**SHOP DRAWING REVIEW**

**BEARING ASSY FOR:**  
 STATE OF VERMONT AGENCY OF TRANSPORTATION

VT ROUTE 73 (RURAL MAJOR COLLECTOR)

PROJECT NOS. BRF 0162(16), (17), (18)	DRAWN CWILLIAMS	DATE 2/10/13	PO # EMAIL
TOWN ROCHESTER	CHECKED .	DATE .	SO NO. & ST. <b>58055 VT</b>
COUNTY WINDSOR	REVIEWED MSPELLMAN	DATE 2/25/14	SHEET 1 OF 2
ROUTE NO 73			
BRIDGE NOS. 15, 16 & 19

**MK.01  
LAMINATED BEARING PADS**

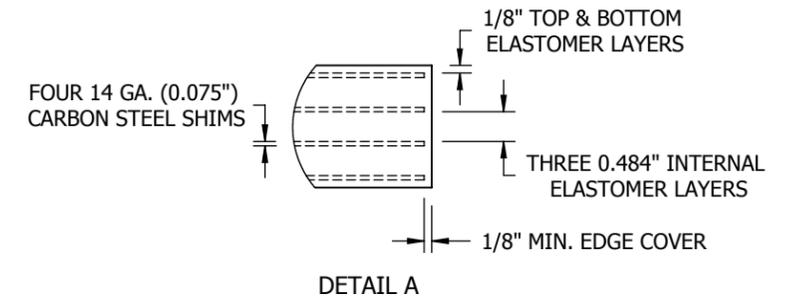
REVIEWER, PLEASE CONFIRM 50 DURO FOR PLAIN PADS

REVIEWER, SEP REQUESTS 1/16" FLATNESS IN LIEU OF 0.001 X NOMINAL

ELASTOMER: LAMINATED.....60 ± 5 DURO NATURAL, GRADE 4  
 ELASTOMER: PLAIN.....(50 ± 5 DURO NATURAL, GRADE 4) *Use 60*
